# UNITED STATES PATENT AND TRADEMARK OFFICE

APPLICATION NO.	FILING DATE	FIRST NAMED INVENTOR	ATTORNEY DOCKET NO.	CONFIRMATION NO.
10/786,695	02/25/2004	Neal Dulaney	35269US1	3686

<b>Office Action Summary</b>	<b>Application No.</b> 10/786,695	<b>Applicant(s)</b> DULANEY, NEAL	
	<b>Examiner</b> Andrea M. Valenti	<b>Art Unit</b> 3643

## DETAILED ACTION

Inlet pipe / Aspiration / Ansaugrohr / Aanzuigbuis

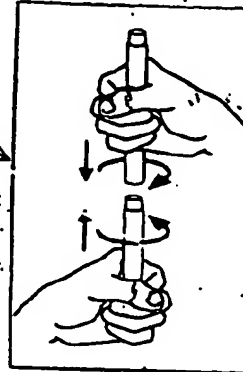
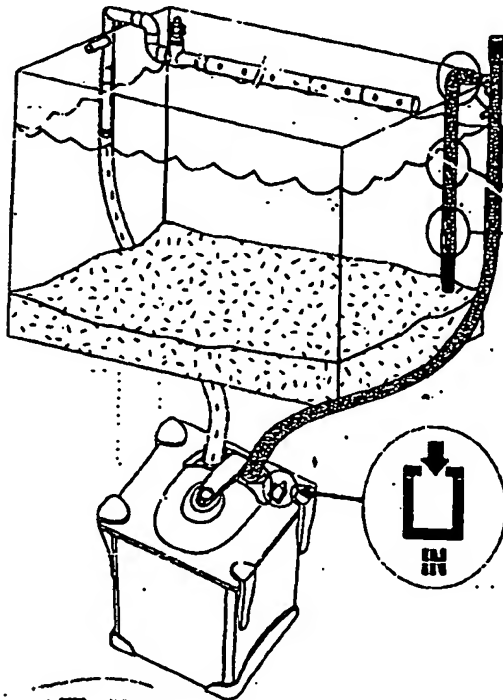
Regarding Claims 1 and 18, FILTERSTAR teaches a modular water flow system for an aquarium (FILTERSTAR page 1 and 2) comprising: a water intake system (FILTERSTAR page 1 Inlet pipe) wherein the water intake system pulls water in from the aquarium through an inlet (FILTERSTAR page 1 Inlet Pipe, shaded pipe in the Fig.) which customizably pulls water in from multiple locations of the aquarium due to a propulsive force created by the pump (FILTERSTAR page 3 teaches it is customizable and is capable of being positioned at various locations within the aquarium); a water return system (FILTERSTAR page 2 Outlet pipe) wherein the water return system permits the water to return to the aquarium from multiple outlets customizable located in multiple locations of the aquarium (FILTERSTAR page 2 Outlet pipe has multiple outlets along its length thus "multiple locations" plus the pipe can be customizable located to different sides of the aquarium page 3); at least one valve assembly (FILTERSTAR page 3 Fig. G) to manage at least one of the water return system and the water intake

Regarding Claim 30, FILTERSTAR as modified teaches the inlet portion is rotatably coupled to the interior portions of the modular water flow system to facilitate positioning of the modular water flow system (FILTERSTAR page 1 and page 3).

Outlet pipe / Reroulement / Ausgangsrohr / Urtlaaf

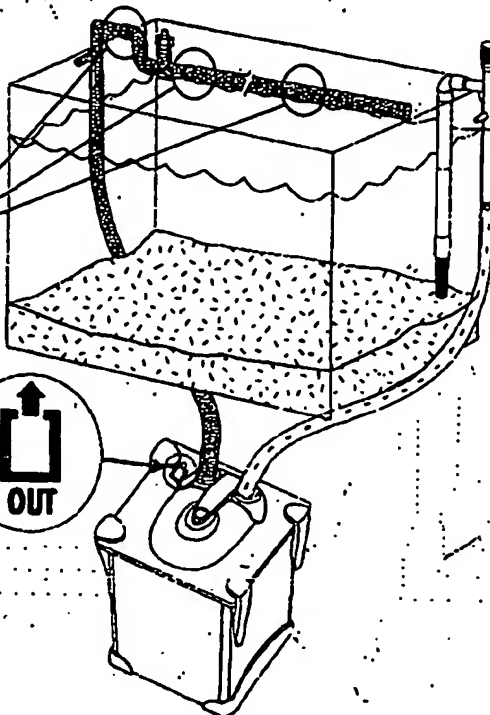
Regarding Claim 9, FILTERSTAR as modified teaches the outlet port is rotatably coupled to the corresponding exterior portion of the modular water flow system (FILTERSTAR page 3 and page 2).
